Staff Report

Re: PLPCCM2016-00299 974 East 2100 South Apartments

Conditional Building & Site Design Review

SHEET NUMBER
AS1.0

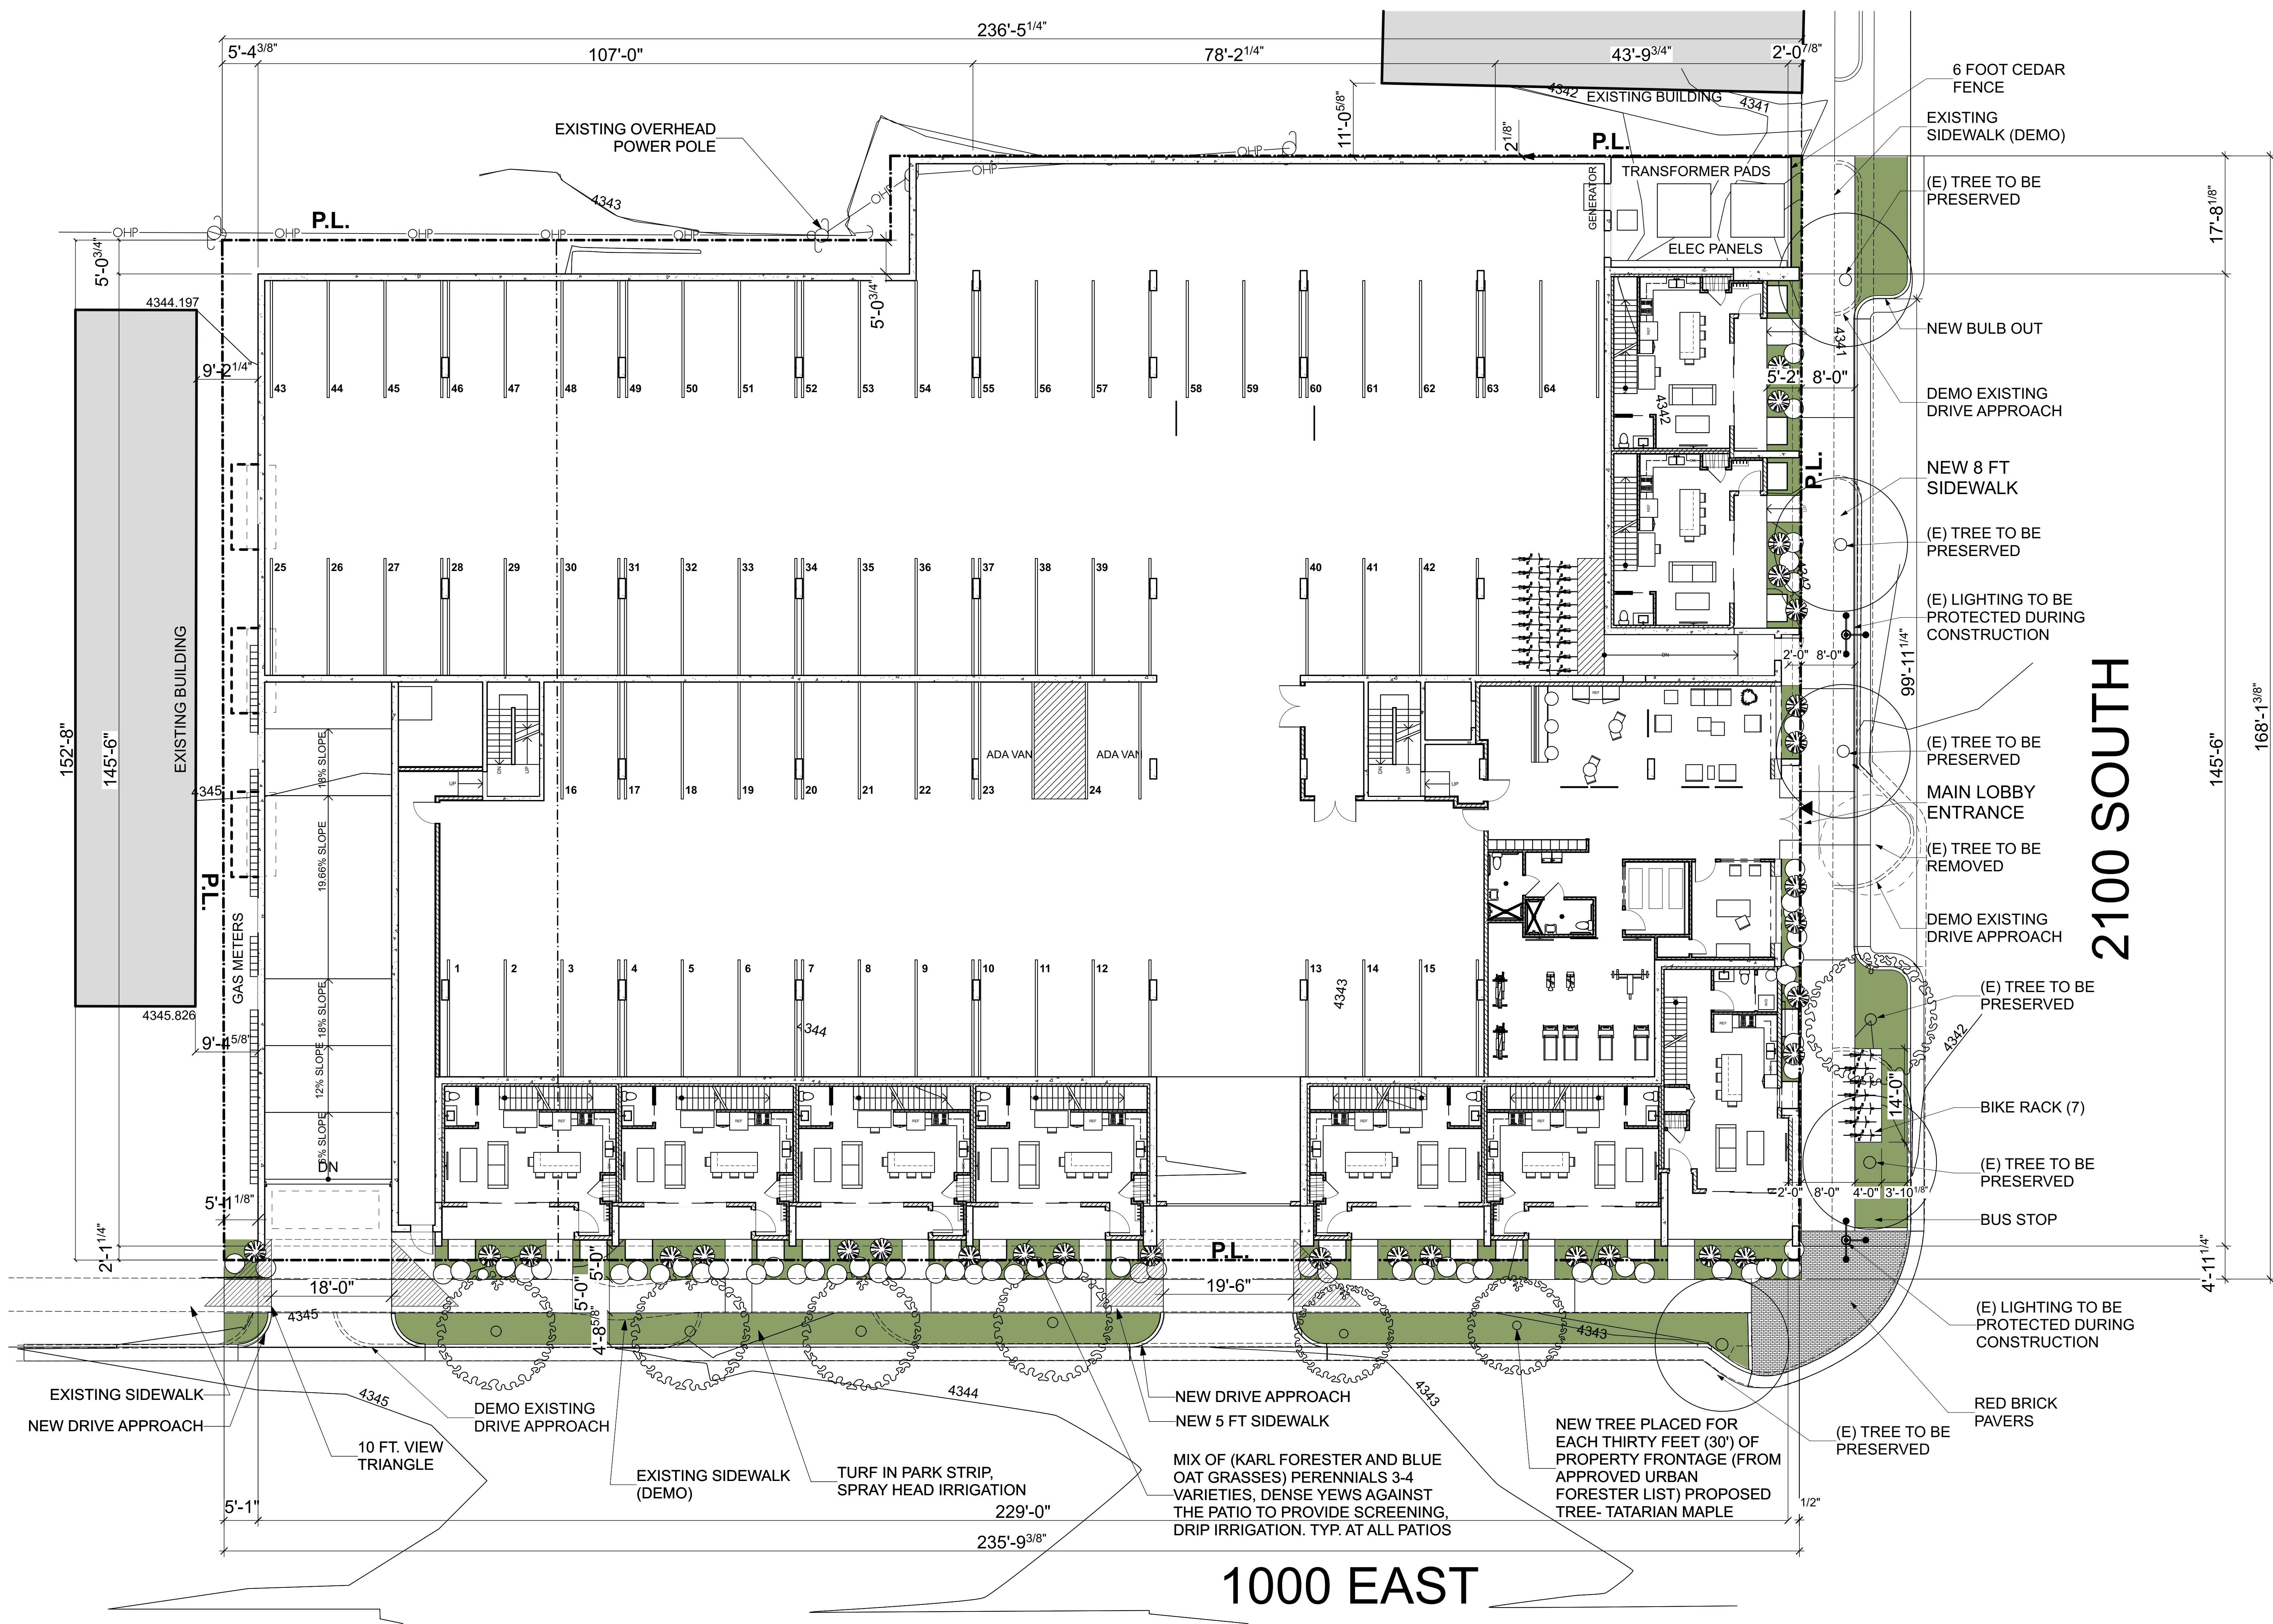
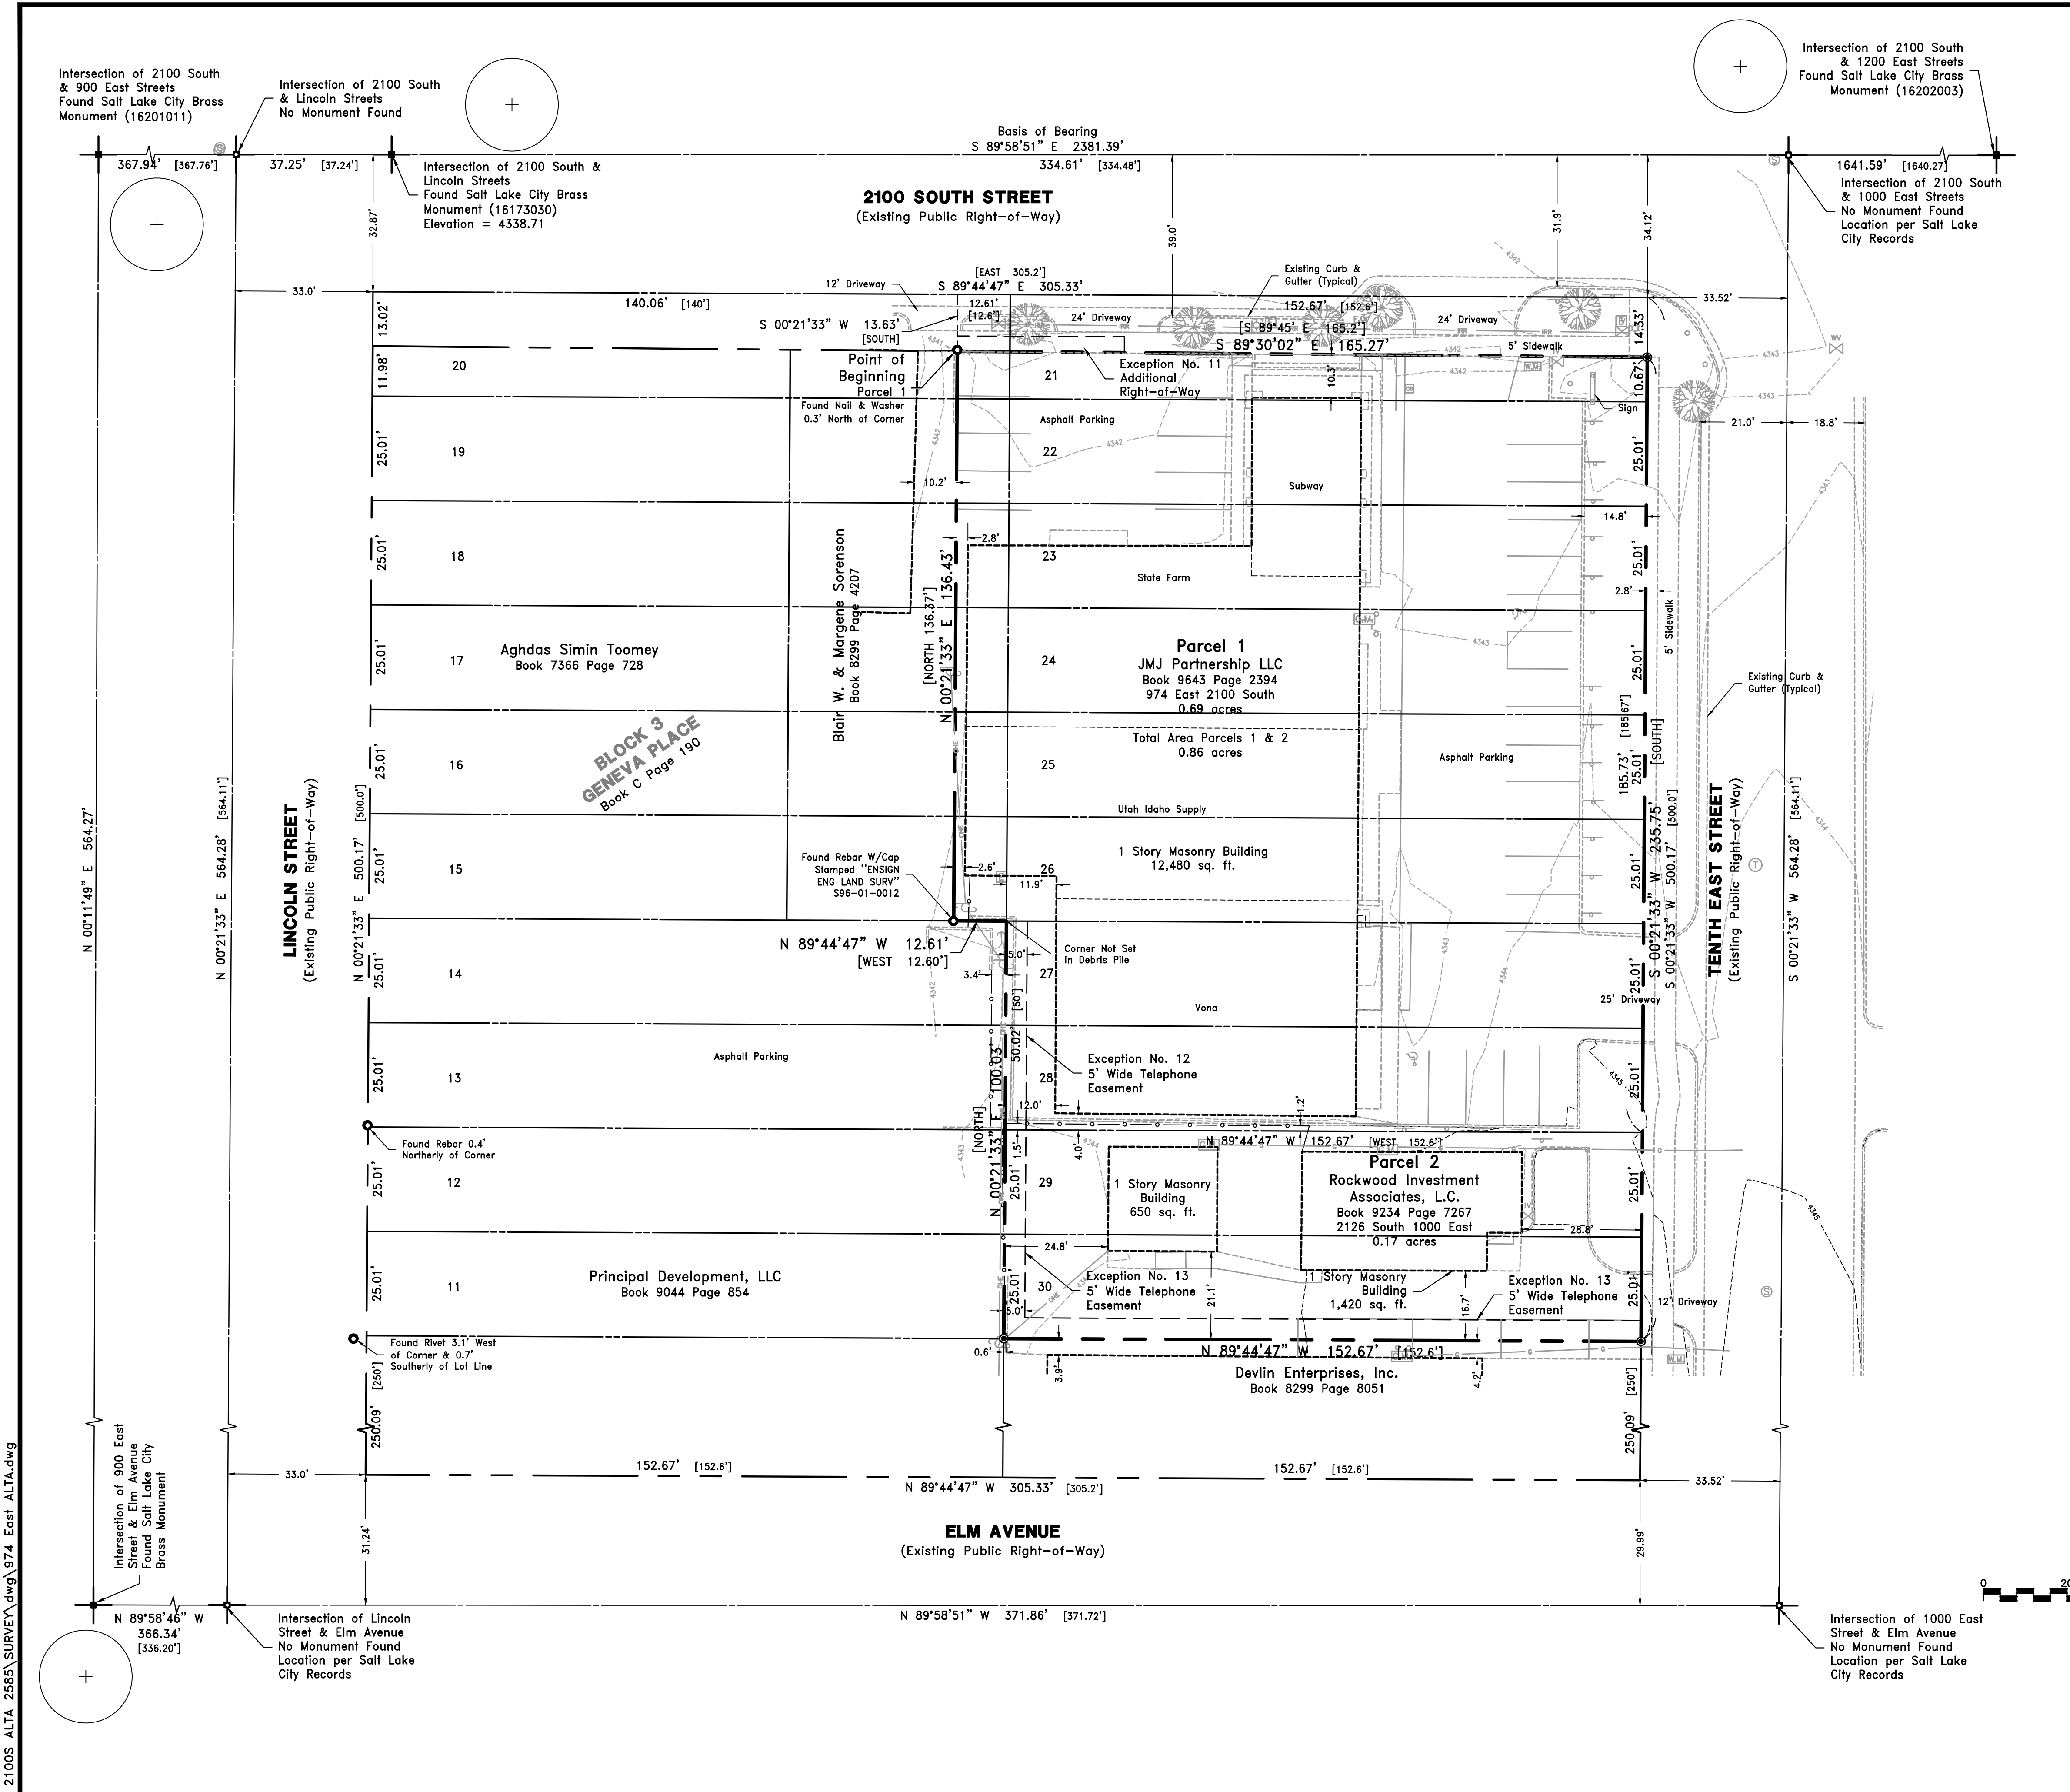
2. The 10' sight distance triangles shown on the site plan at the driveways onto 1000 East are not drawn correctly; please refer to Illustration I in 21A.62.050 for correct sight distance triangle location. Sight distance triangle requirements must be considered for the driveway on the adjacent property on 2100 S by transformers where a 6 foot cedar fence is proposed.

3. Driveway ramps must comply with SLC Transportation Standard Detail E2.b1, Maximum Driveway Slopes and Critical Angles.
4. Provide details for bicycle parking.

5. Electric vehicle parking spaces are not shown on plan; E.V. parking spaces shall be signed in a clear and conspicuous manner, such as special pavement marking or signage, indicating exclusive availability to electric vehicles; and outfitted with a standard electric vehicle charging station.
